Federal Highway Administration July 8, 2011

In Reply Refer To: HSST/CC-90B

Name of system: TTMA-100 Type of system: Trailer-Mounted Attenuator (TMA) Test Level: NCHRP Report 350 TL-3 Testing conducted by: Safe Technologies, Inc. Date of request: December 23, 2010 Request initially acknowledged: January 4, 2011

Enclosure 1

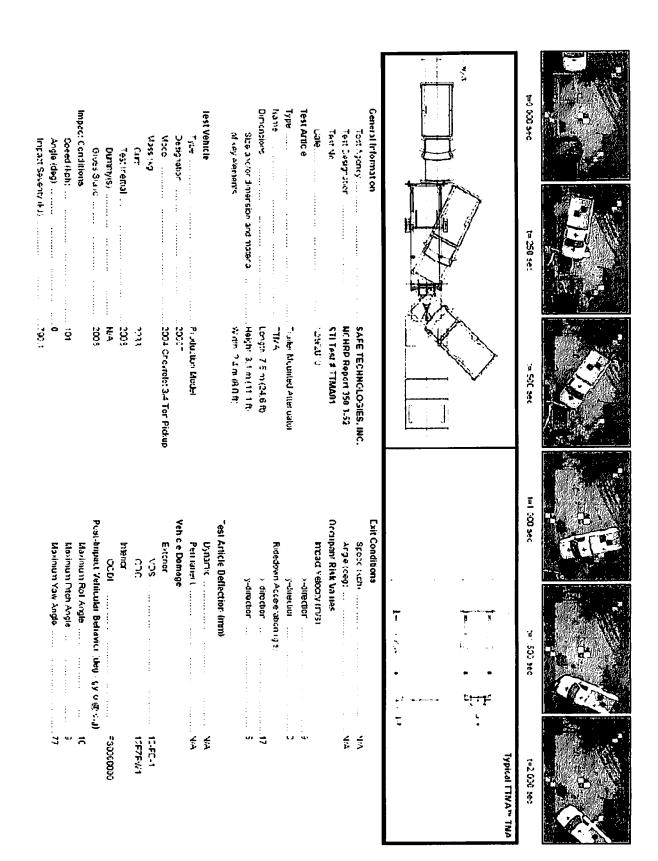
The general design of the Trailer TMA, as tested, is shown in Enclosure 1. I am assuming that users may obtain detailed drawings directly from you and that such drawings will accurately depict the device that was tested.
